# MEMO

Re: Stone Retaining Wall located on 40 N High and partially on 38 N High;  
Informal Review of Submittals, Preservation POV

Fig. 2: View of retaining wall, looking northwest at the southeast corner (Kooi, Bernie. *Overall view of wall*. 2021. 40 North High Street, Korda/Nemeth Engineering, Inc. 2021, p.1).

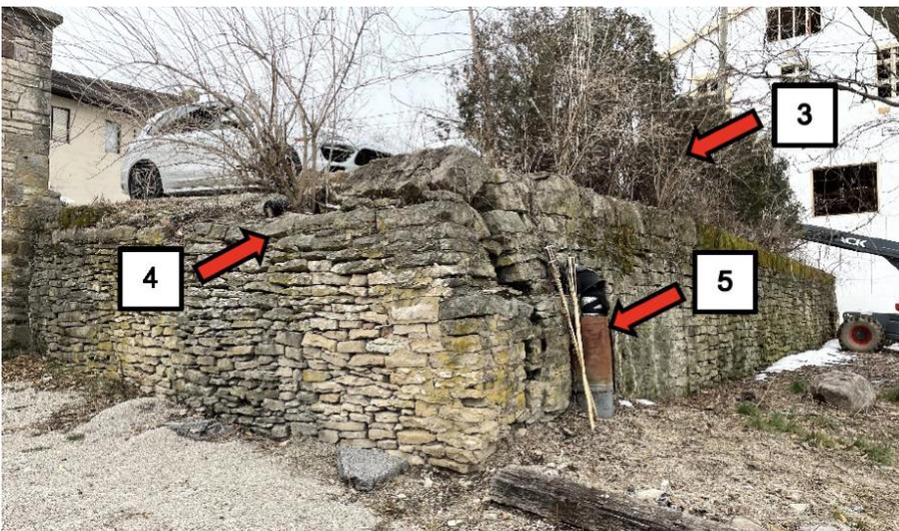
- Regarding the exposed sewer pipe penetrating the east wall (see note 5 in Fig. 2), please provide information on how rebuilding the wall would be best accomplished, also taking into account if the sewer pipe were to stay as-is, or if the sewer pipe could be moved westward, inside the eastern wall during the rebuild (the preferred option). If the sanitary pipe were to stay as-is, what additional work is needed, including mortaring, sanitary repairs, etc? Please provide any details of this work if this work is approved.

PHOTO 2: Possible original drainage outlet found on the eastern retaining wall (Preservation Designs, May 2021).

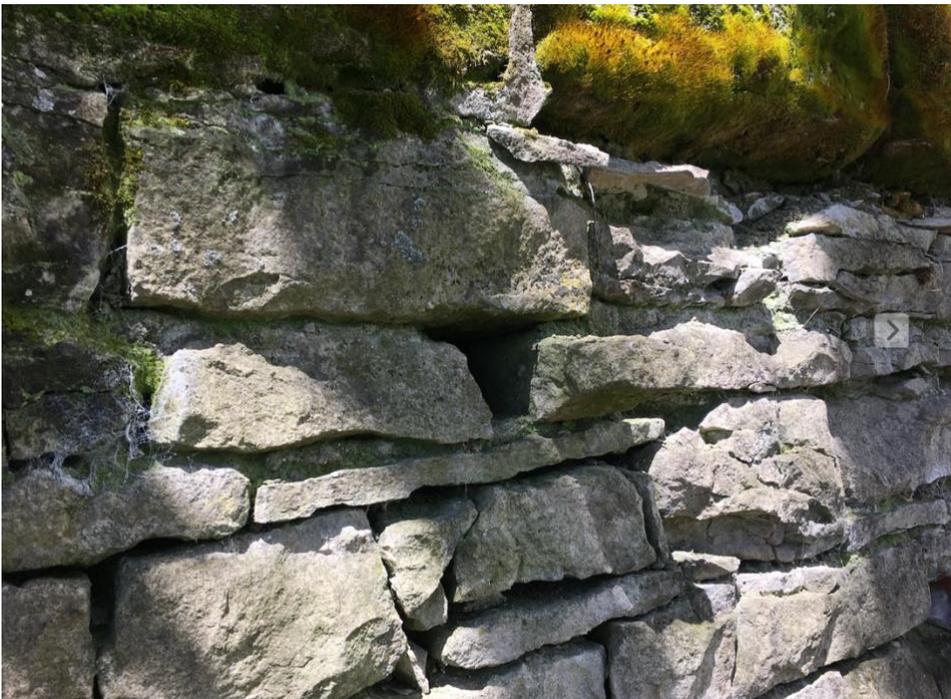
- Regarding the drainage of the new perforated PVC to be installed (see notes regarding Osborn Drawings), if Vic Art Masonry has any familiarity with what a drainage point would have looked like historically, whether similar to what is seen in PHOTO 2 or is typical historically for Central Ohio, please provide this information for review and the project's potential use.
